**To:** General Purposes Committee

**File:** RZ 18-825323

**Re:** Application by CDS-Chen Design Studio Ltd. for Rezoning at  
6560 Granville Avenue from the "Single Detached (RS1/E)" Zone to the "Compact  
Single Detached (RC2)" Zone

## Staff Report

**SITE PLAN**

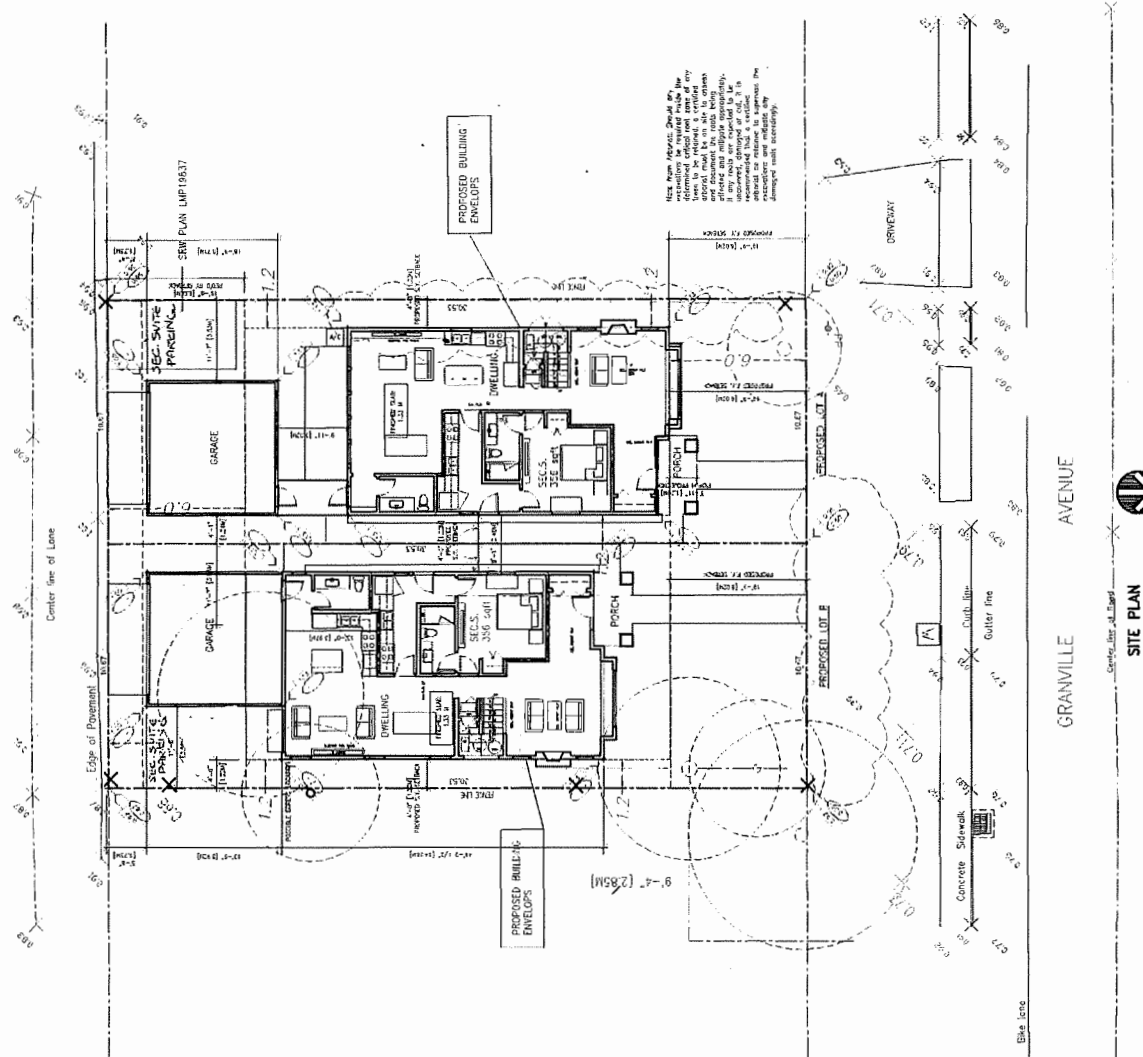
The proposed development is generally in compliance with the “Compact Single Detached (RC2)” zone in Richmond Zoning Bylaw 8500. However, in order to provide a 4 m tree protection fencing area around Tree# 53 and Tree# 54, an increased front yard setback is required. This would result in a shifted building footprint towards the rear which then in turn impacts the rear yard setback to the garage as well as the provision of private outdoor space. If building separation between the house and the garage was available and compliant with “Compact Single Detached (RC2)” zoning, the rear yard setback would be a minimum of 1.2 m. By reducing the rear yard setback requirement of 6.0 m to 1.73 m, an attached garage can be provided, the front yard trees can be protected, and the 1.5 m wide SRW for City Utilities along the rear lot line respected. With the building footprint on Lot B shifted towards the rear, tree protection and secondary suite parking requirements, the private outdoor space will need to be included in the front yard instead of the rear yard. Therefore, a variance will be required to amend the regulation of a minimum of 20 m<sup>2</sup> of private outdoor space on the lot outside of the front yard.

The applicant is requesting two variances to reduce the minimum rear yard setback in Lot B from 6.0 m to 1.73 m for a one storey garage to be attached to a proposed single-family dwelling zoned “Compact Single Detached (RC2)”, and to allow the minimum 20 m<sup>2</sup> of private outdoor space to be provided in the front yard on Lot B.

Staff support the requested variance as the Arterial Road Guidelines for Compact Lot Development in the OCP encourage retaining existing trees wherever possible, particularly if the trees are in the front yard. The requested variances will enable successful retention of the tree and further use of the front yard space. The variances will be considered through a Development Variance Permit (DVP) process which would follow the adoption of the rezoning bylaw. Subdivision approval is required prior to DVP issuance as the variances are requested for Lot B only.

### Tree Management Plan

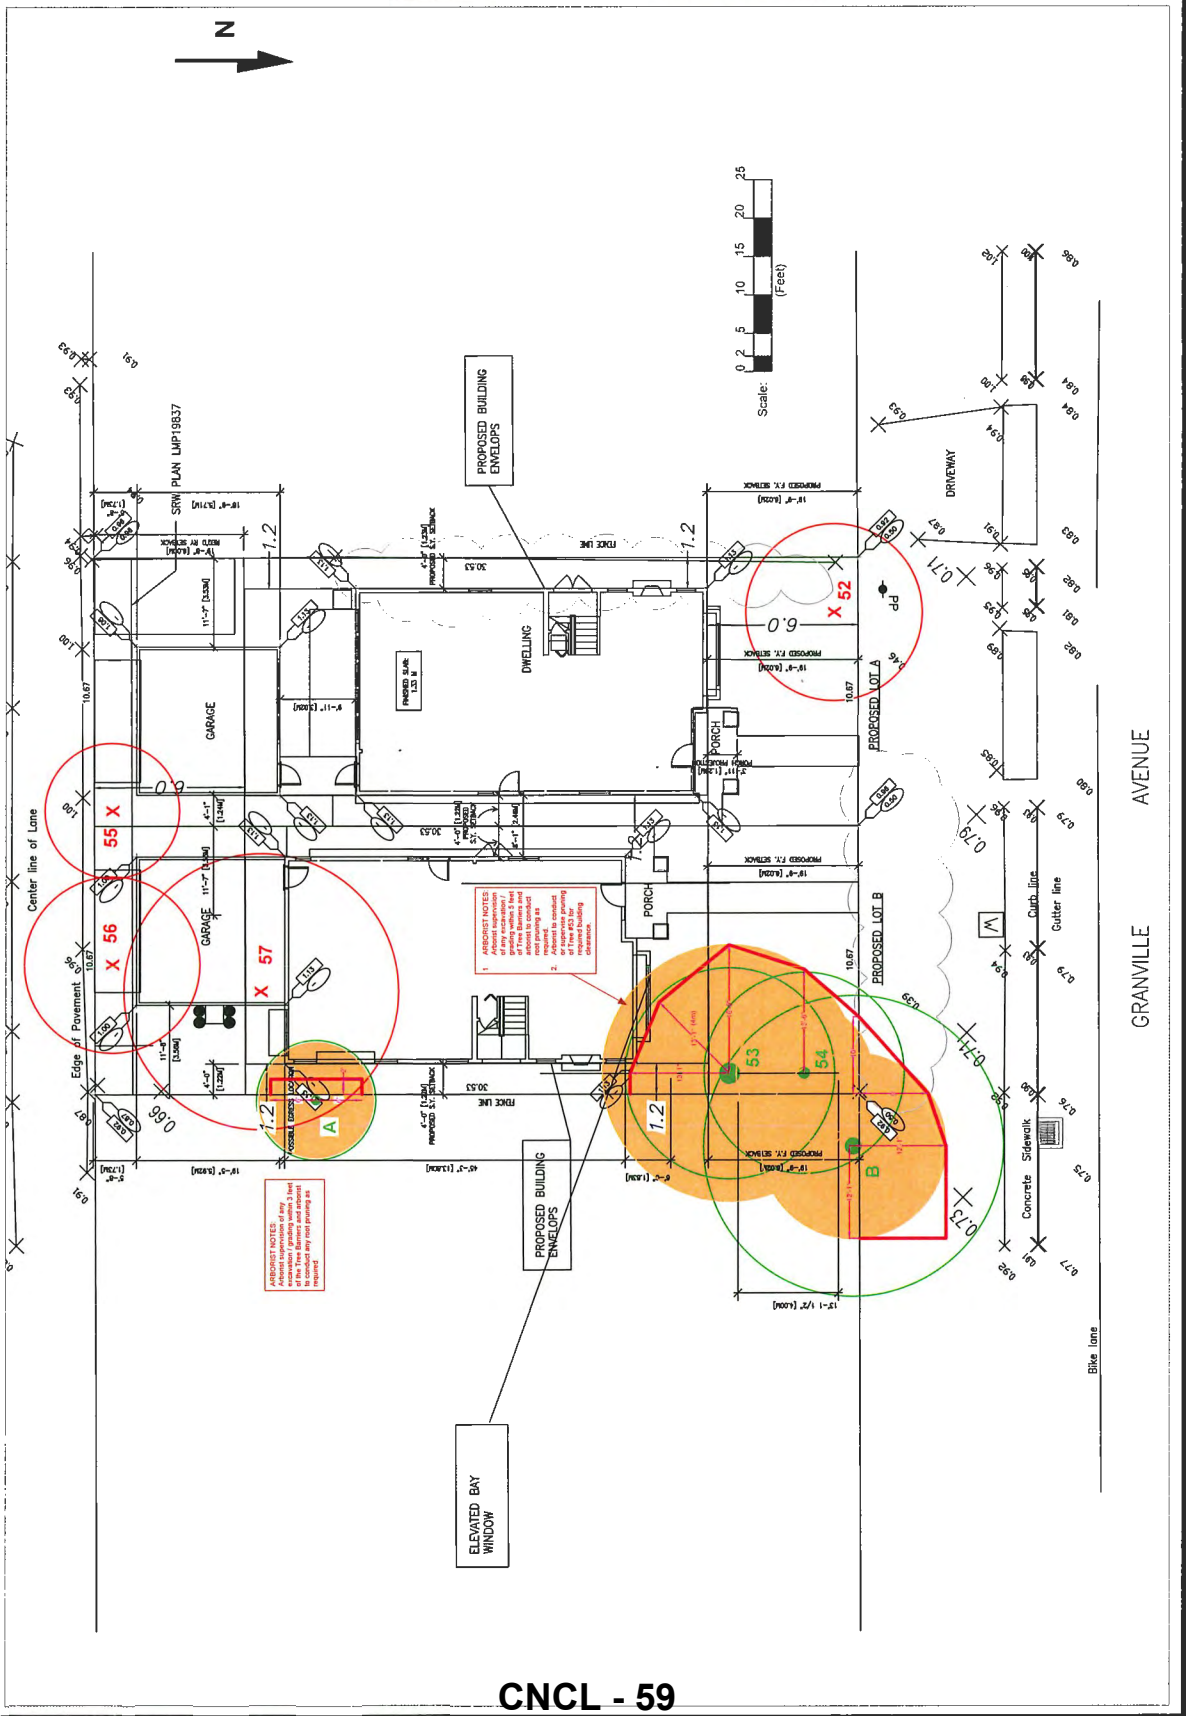
The City's Tree Preservation Coordinator has reviewed the Arborist's Report and supports the Arborist's findings, with the following comments:

- One Cypress tree (Tree# 52, multi-stem 48 cm dbh) and one Rubinia tree (Tree# 57, multi-stem 34 cm dbh) located on the development site are either dead, dying (sparse canopy foliage), infected with Fungal Blight or exhibit structural defects such as cavities at the main branch union and co-dominant stems with inclusions. As a result, these trees are not good candidates for retention and should be replaced.

- Two Cypress trees (Tree# 53, multi-stem 54 cm dbh; Tree# 54, 43 cm dbh) located on the subject property are in fair to good condition. Tree# 53 is just outside of the allowable building envelope and Tree# 54 is located outside the proposed building envelope. In order to protect both trees as per the Tree Protection Bylaw 8057, trees will require a minimum of 4 m of tree protection area from the base of the stems for successful retention. To ensure this retention is successful, the front yard setback needs to be significantly increased from 6.0 m to 8.6 m. This then triggers the need to provide a house with an attached garage on Lot B due to the shift of the building footprint to the rear to accommodate the front yard trees. In order to comply with zoning requirements for an attached garage a separate Development Variance Permit will be required to enable a reduced rear yard setback from 6.0 m to 1.73 m allowing an attached garage in the rear yard and tree protection in the front yard. The relocation of private outdoor space to the front yard will also require a variance as an attached garage and secondary suite parking would limit the availability of space in the rear yard.

- Two undersized trees, one Pear (Tree# 55), and one Plum (Tree# 56), located on the development site and along the rear property line are in fair to poor condition. With existing stem defects, structural damage, poor quality pruning, and conflict with the proposed driveway access and new sanitary connections, these trees are not good candidates for retention and should be removed.

- One Cedar tree (Tree# A, 43 cm dbh) and one Fir tree (Tree# B, 62 cm dbh) located on the neighbouring property to the east are to be protected as per City of Richmond Tree Protection Information Bulletin Tree-03.

- Replacement trees should be specified at 2:1 ratio as per the OCP.

Two trees (Tree# 53, 54) on the subject property and two trees (Tree# A, B) on the eastern neighbouring property are to be retained and protected. The applicant has submitted a tree protection plan showing the trees to be retained and the measures taken to protect them during development stage (Attachment 5). To ensure that the trees identified for retention are protected at development stage, the applicant is required to complete the following items:

The applicant wishes to remove two bylaw-sized on-site trees (Tree# 52, 57) and two undersized trees (Tree #55, 56). The 2:1 replacement ratio for bylaw sized trees would require a total of four replacement trees. The applicant has agreed to plant two replacement trees on each lot proposed in addition to one more new tree in Lot A, for a total of five trees. The required replacement trees are to be of the following minimum sizes, based on the size of the trees being removed as per Tree Protection Bylaw No. 8057.

- Prior to final adoption of the rezoning bylaw, submission of a \$20,000 Tree Survival Security based on the sizes of the bylaw-sized trees on the subject property to be retained (Tree# 53, 54).

- Prior to demolition of the existing dwelling on the subject site, installation of tree protection fencing around all trees to be retained. Tree protection fencing must be installed to City standard in accordance with the City’s Tree Protection Information Bulletin Tree-03 prior to any works being conducted on-site, and remain in place until construction and landscaping on-site is completed.
